I oppose SSD- 30759158, Minarah College D.A

Upon reviewing the various reports and varying amounts of information, I object to this proposal.

**Figure 12: Image showing the boundary of the study area in red and the yellow hatched area showing the archaeological survey coverage. Aerial image source Six Maps © Department Finance, Services and Innovation, NSW Government.**

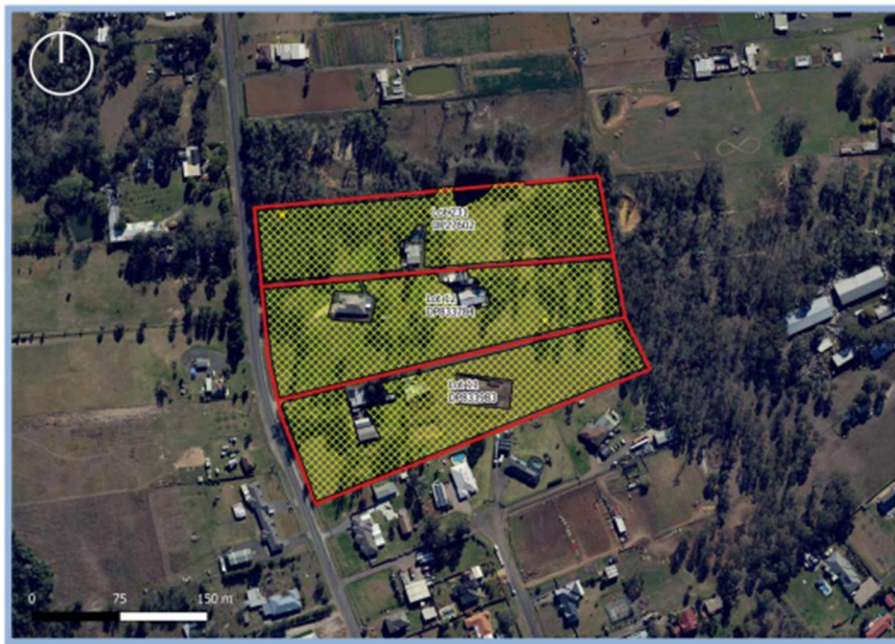
Lastly, I have major concerns in relation to **Appendix Y**, Fig 12 (below). Why has the applicant requested three adjacent properties be surveyed? Is there a further application that has not yet been revealed that will further increase the road traffic and noise to the area?
